Hazardous Waste Ground-Water Task Force

Evaluation of Wyman-Gordon Company North Grafton, Massachusetts

**UPDATE OF THE HAZARDOUS WASTE GROUND-WATER TASK FORCE
EVALUATION OF WYMAN-GORDON COMPANY**

**FIGURE 2
SURFACE IMPOUNDMENT
AND MONITORING WELL LOCATIONS**

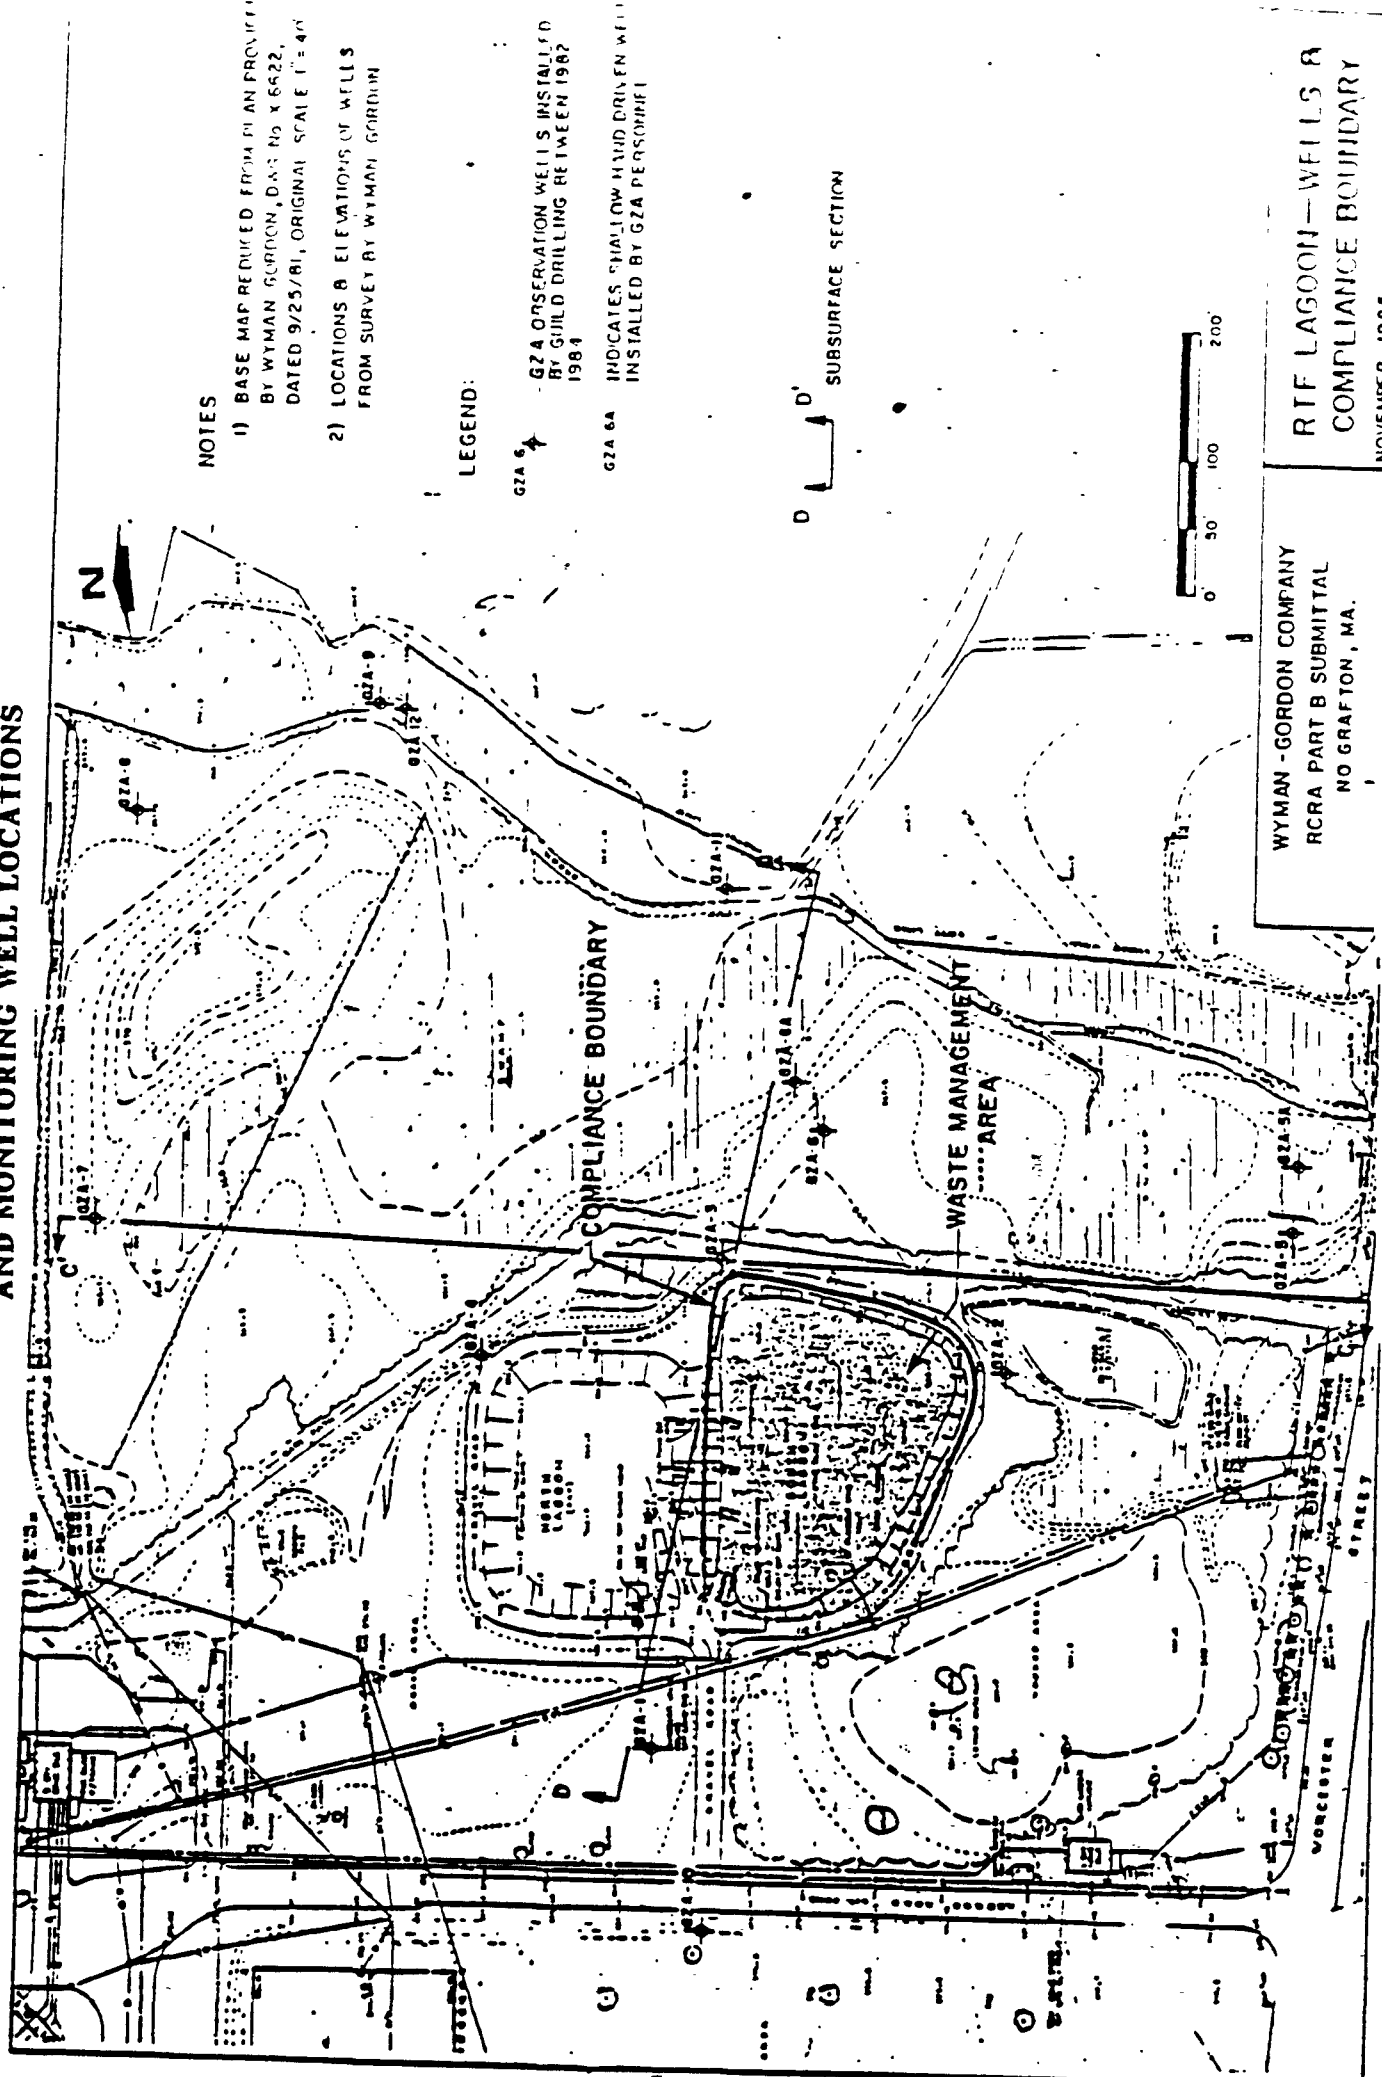
- o 40 CFR Part 265.91(a)(1) and (2) -- Wyman-Gordon initially assumed that ground-water flow direction was to the northeast. At the time of well installation (July 1982), Wyman-Gordon designated three of the four wells as downgradient wells (GZA-2, -3, -4), and the remaining well (GZA-1) as upgradient. Water level measurements taken in July 1982 indicated mounding in the ground-water surface as a consequence of the RTF lagoons. This resulted in all four wells being downgradient. No upgradient well existed until the installation of GZA-10 well in 1984.

- o 40 CFR Part 265.91(c) -- Monitoring wells are not adequately sealed to prevent contamination from entering the screened interval from above, thus affecting the integrity of ground-water samples. At the time of the Task Force inspection, several wells were not sealed at the surface (see Table 1). In addition, the bentonite seals are approximately 1 foot thick (see Table 4). Industry standards generally call for at least 2-foot-thick seals. In addition, at the time of the Task Force inspection, wells GZA-2, GZA-3, GZA-4, GZA-6, GZA-6A, and GZA-10 did not have concrete collars and/or PVC caps (see Table 1), adding to the possibility that contamination may infiltrate the well from the surface.

- o Screen lengths in all wells are the entire length of the saturated zone. This does not allow for sampling discrete portions of the highly variable unconsolidated sediments.

- o Ground-water surface elevations and well casing heights were measured only to the nearest 0.1 foot. Elevations should be taken to the nearest 0.01 foot to ensure accurate flow evaluations and to provide a check on the integrity of the well (e.g., identify siltation problems). The Task Force did note that well depths have become shallower, which may indicate that siltation has occurred (see Table 5).

- o Implement a quarterly monitoring program that includes sampling a number of surface and ground-water points at the boundaries of and within the contaminant plume and at any environmental receptors, sufficient to define the migration rate of the contaminant plume.

- o Implement a sampling program that includes sampling for a number of parameters sufficient to define the composition of the contaminant plume.
- o Measure ground-water elevations in all wells and the surface elevation of East Brook on a quarterly basis.
